7. If Unit or CA/Agreement, Name and/or No.
891005247X8. Well Name and No.
COTTON DRAW UNIT 221H9. API Well No.
30-015-42514-00-X110. Field and Pool, or Exploratory
PADUCA11. County or Parish, and State
EDDY COUNTY, NM**SUBMIT IN TRIPLICATE - Other instructions on reverse side.**

Devon Energy Production Co. L.P. respectfully requests to use a FMC uni-head system for the subject well.

**PECOS DISTRICT
CONDITIONS OF APPROVAL**

OPERATOR'S NAME:	Devon Energy Production Company, L.P.
LEASE NO.:	NMNM-0503
WELL NAME & NO.:	Cotton Draw Unit 221H
SURFACE HOLE FOOTAGE:	0170' FSL & 1460' FWL
BOTTOM HOLE FOOTAGE:	0330' FNL & 0660' FWL
LOCATION:	Section 01, T. 25 S., R 31 E., NMPM
COUNTY:	Eddy County, New Mexico
API:	30-015-42514

DM100161771-2A

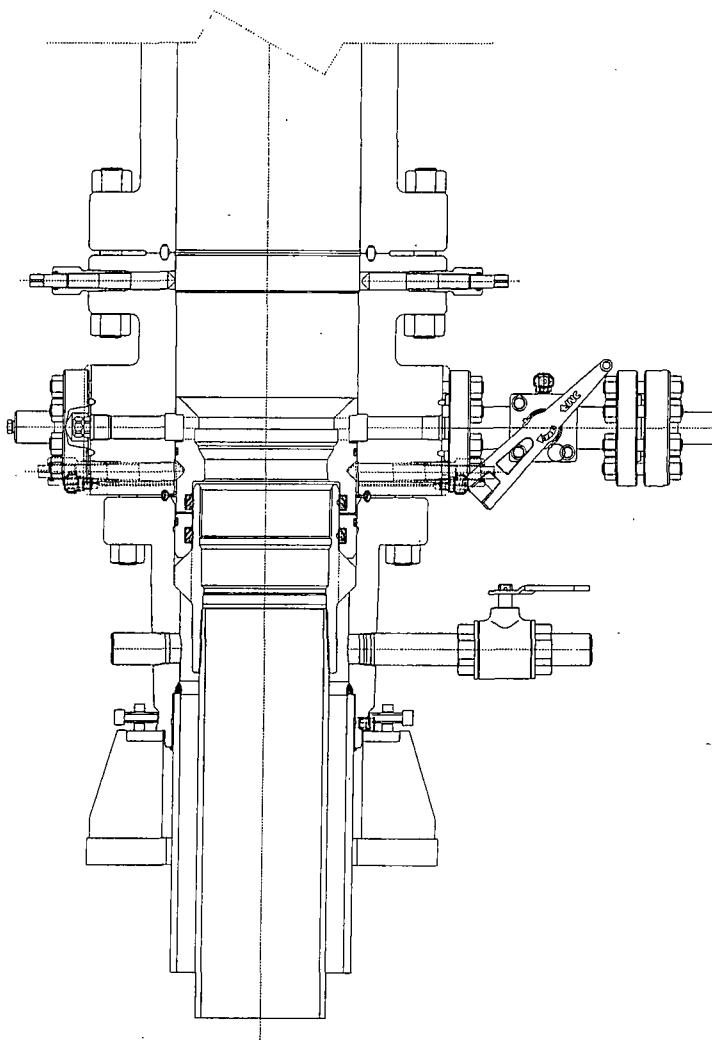
See COA
Devon proposes using a multi-bowl wellhead assembly (FMC Uni-head). This assembly will only be tested when installed on the surface casing. Minimum working pressure of the blowout preventer (BOP) and related equipment (BOPE) required for drilling below the surface casing shoe shall be 3000 (3M) psi.

- FMC representative will install the test plug for the initial BOP test.
- FMC will install a solid steel body pack-off to completely isolate the lower head after cementing intermediate casing. After installation of the pack-off, the pack-off and the lower flange will be tested to 5M, as shown on the attached schematic. Everything above the pack-off will not have been altered whatsoever from the initial nipple up. Therefore the BOP components will not be retested at that time.

3. **Operator has proposed a multi-bowl wellhead assembly. This assembly will only be tested when installed on the surface casing. Minimum working pressure of the blowout preventer (BOP) and related equipment (BOPE) required for drilling below the surface casing shoe shall be 3000 (3M) psi.**

- a. Wellhead shall be installed by manufacturer's representatives, submit documentation with subsequent sundry.
 - b. If the welding is performed by a third party, the manufacturer's representative shall monitor the temperature to verify that it does not exceed the maximum temperature of the seal.

- c. Manufacturer representative shall install the test plug for the initial BOP test.
 - d. Operator shall perform the intermediate casing integrity test to 70% of the casing burst. This will test the multi-bowl seals.

- e. If the cement does not circulate and one inch operations would have been possible with a standard wellhead, the well head shall be cut off, cementing operations performed and another wellhead installed.

DM100161771-2B

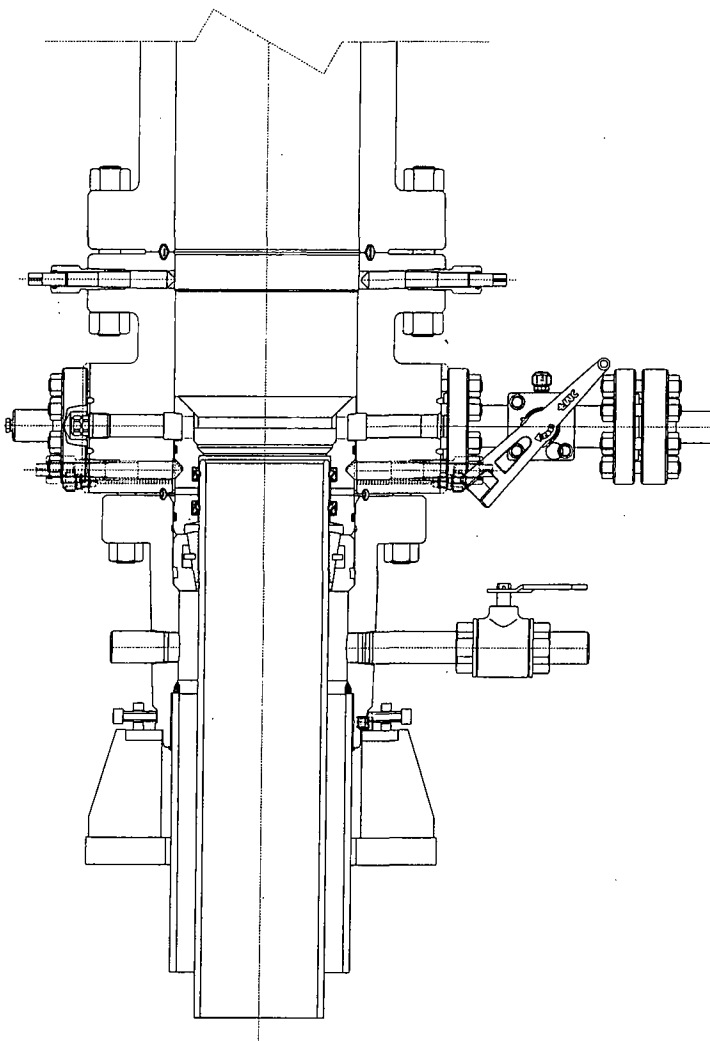
CONTINGENCY MODE
